**Draft Meeting Summary
Brook Stream 12 November 2008**

Nile Street Culvert 0915 hours

8. Top of concrete open channel section looking 600m downstream

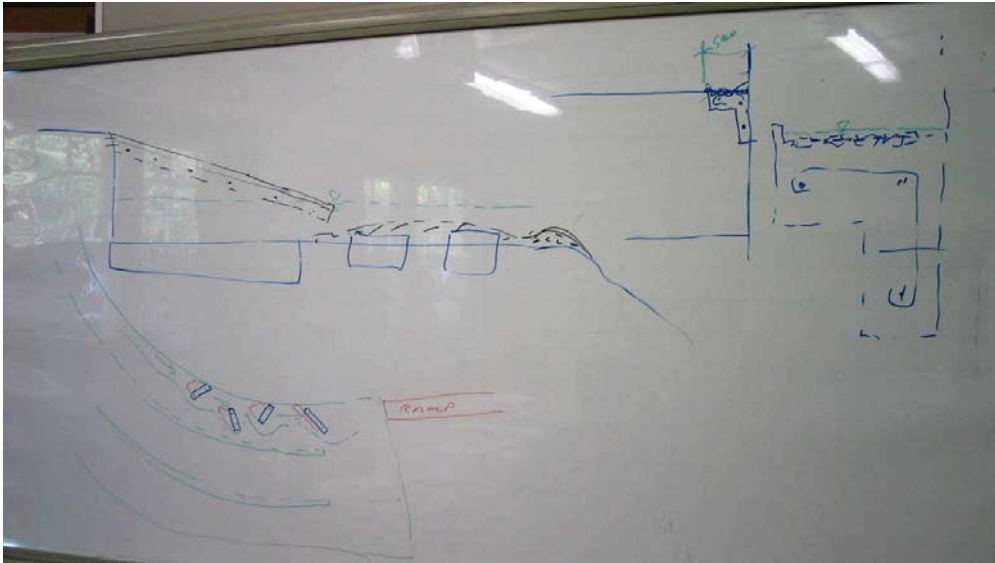
- The bed of this channel has been resurfaced and a meandering low flow channel installed. The work was completed last year at a cost of \$40,000/100m or \$240,000.00 for the job.
- A long-term option was identified by Les Basher that included the removal of the concrete base but it would be necessary to conduct remedial work to ensure the stability of the walls.
- Planting opportunities are marginal with no soil, or very poor soil conditions. Shade sails could be an option, if it was shown that water temp is enough of an issue.
- Fish passage is possible through this section but there are no large resting/cover areas. Rat predation and high water temperatures were identified as possible issues though NCC currently undertakes rat poisoning operations. .
- Placement of rocks in the low flow channel would be expensive and could compromise the design hydraulics of the channel

Manuka Street Ford & Open Channel

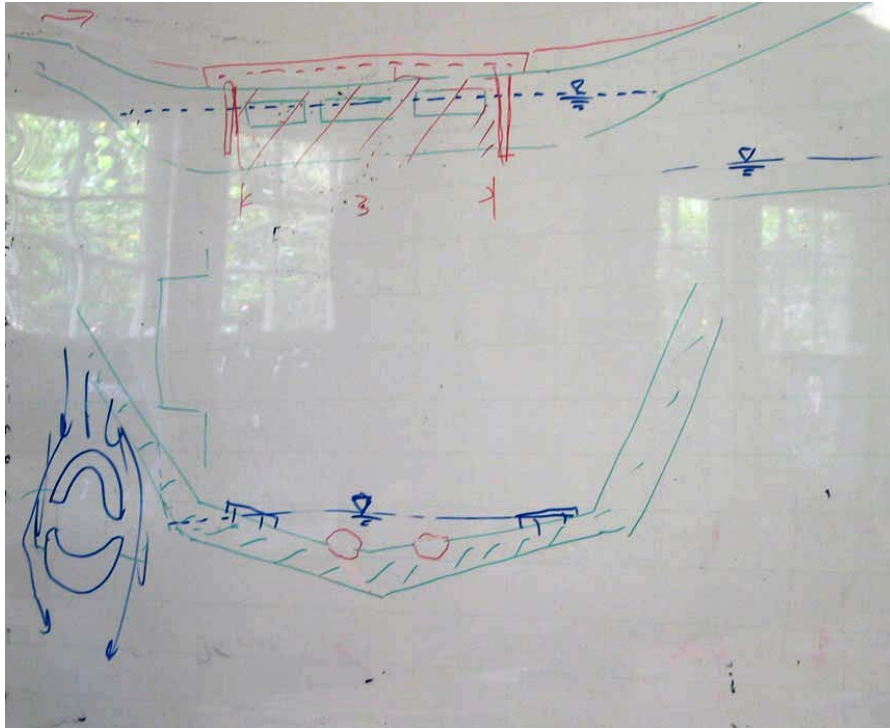
- There was agreement to remove the three existing culverts and the central portion of the ford and replace it with a pre-cast slab to form a low bridge. The estimated cost would be in the neighbourhood of \$15,000-\$30,000 pending the amount of reinforcement required at each end and the cost of a pre-cast bridging slab. Resource Consent is required for this work.
- This would be an ideal project if the proposed \$100,000.00 allocation for engineering works on the Brook Stream was approved.
- Fish monitoring would be required prior to and after installation.
